BUILDING FRONTAGE IMPROVEMENTS

STATION ROAD - ASHINGTON

THE PROJECT SO FAR...

YOUR VIEWS MATTER

NORTH SIDE

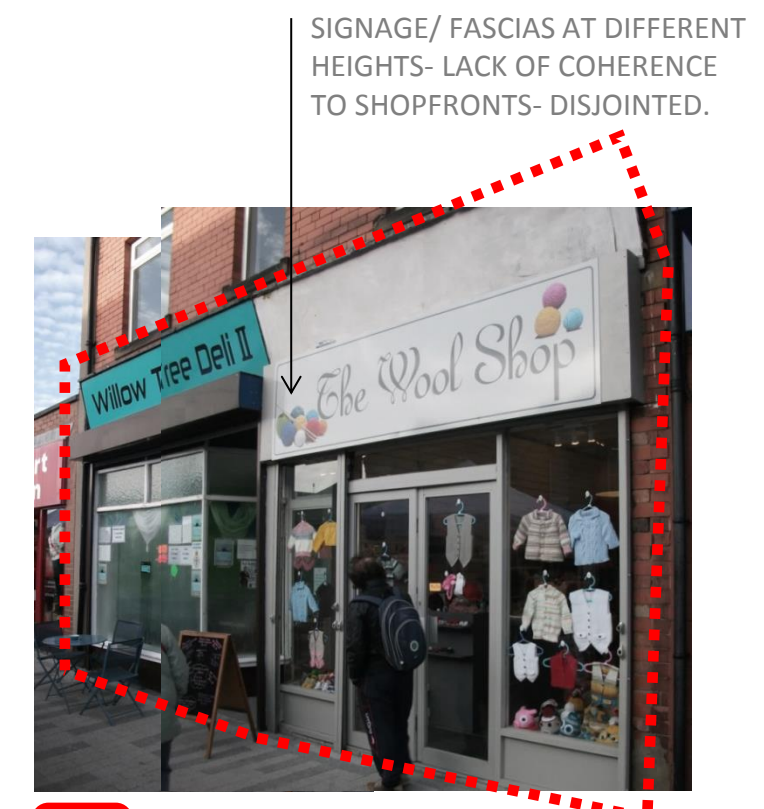
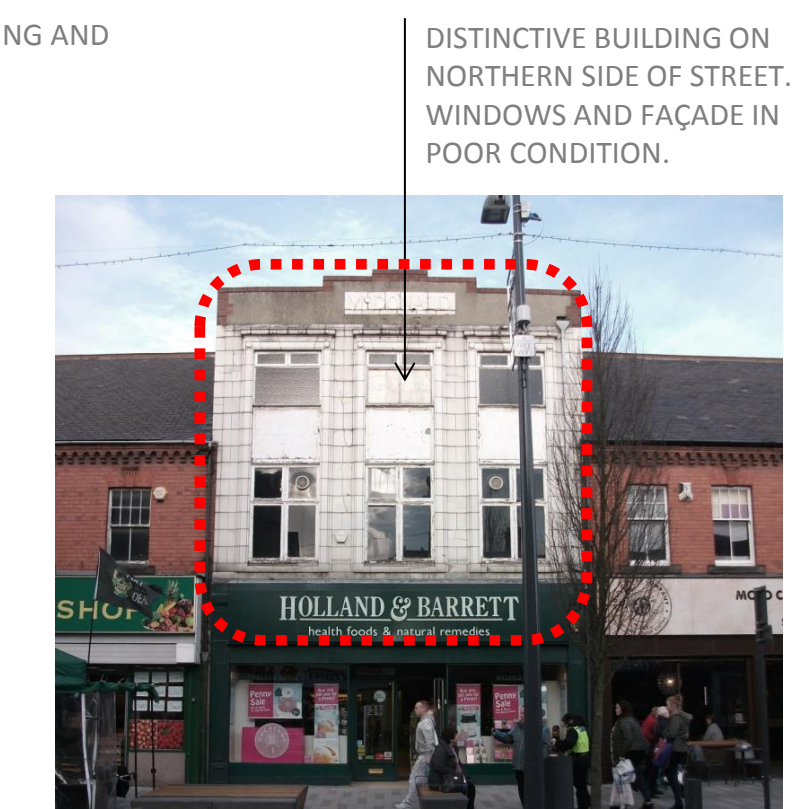
COMMENTS NOTED VARYING HEIGHTS OF SIGNAGE AS A NEGATIVE

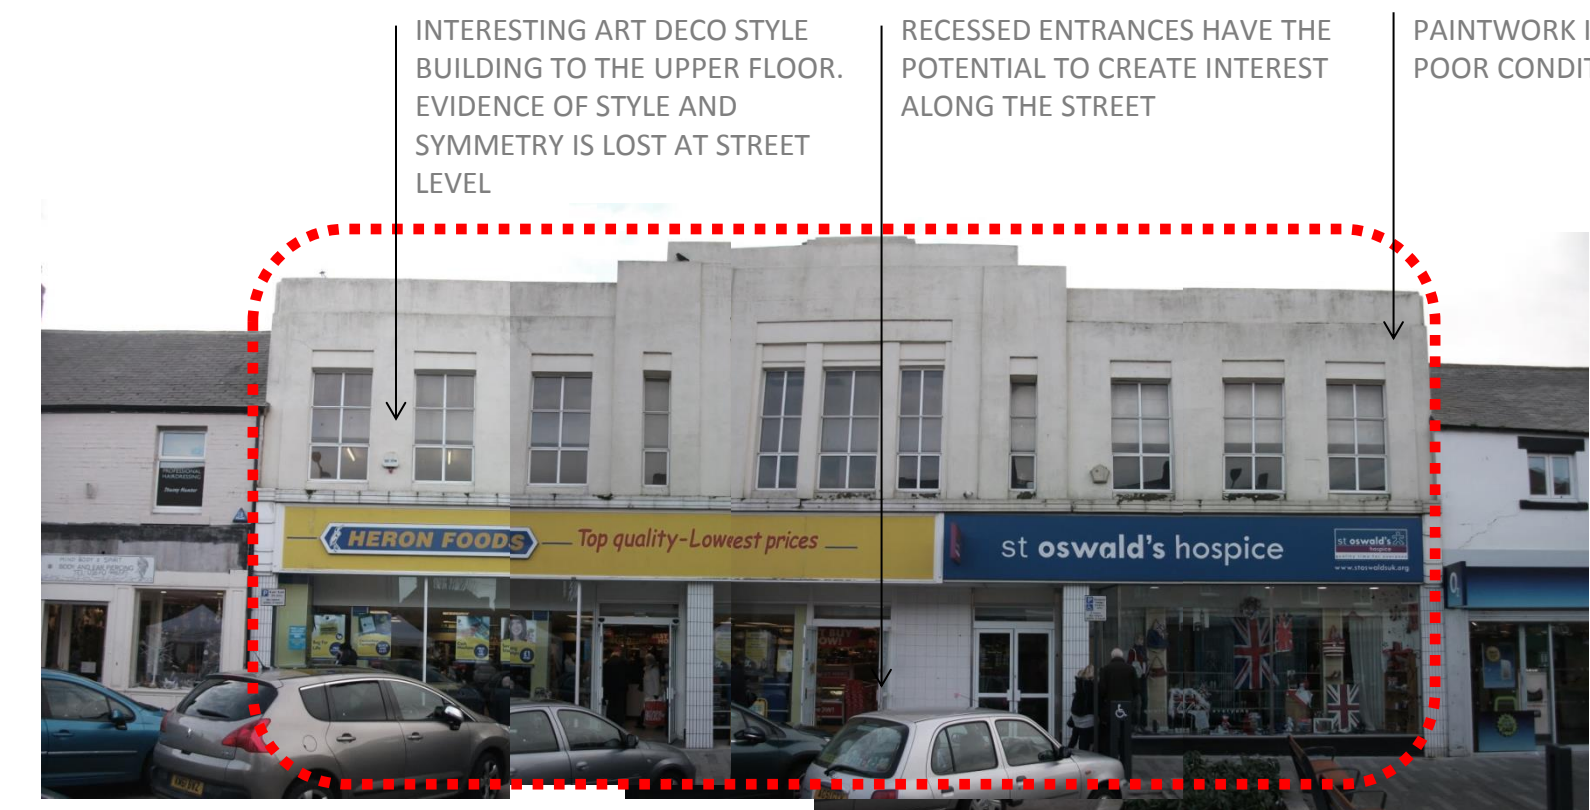
POSITIVE REACTION TO ARTWORK SUGGESTION

HISTORIC IMAGES OF STATION ROAD

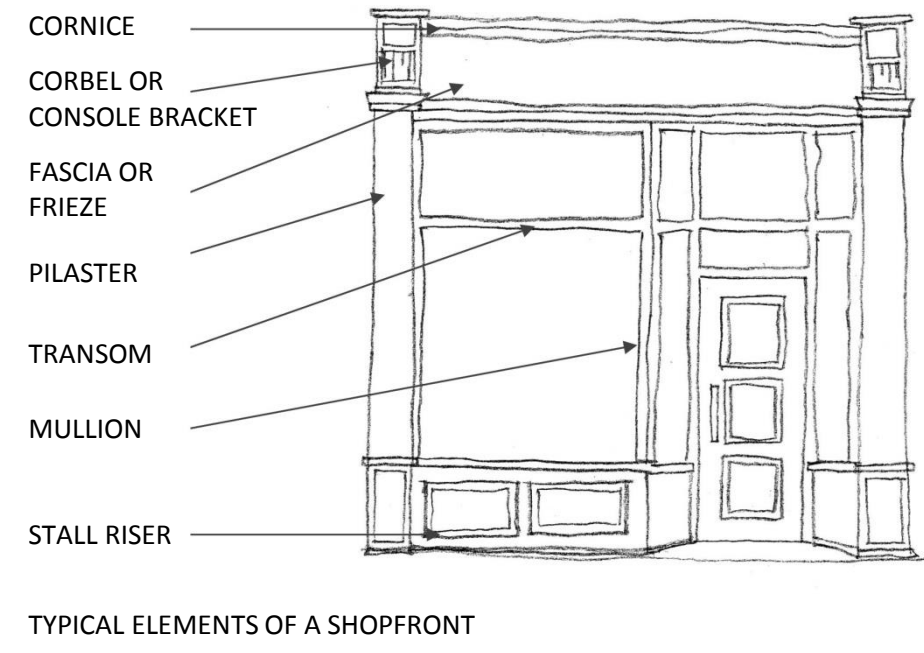
POSITIVE REACTION TO INSTALLING HISTORIC SHOPFRONTS
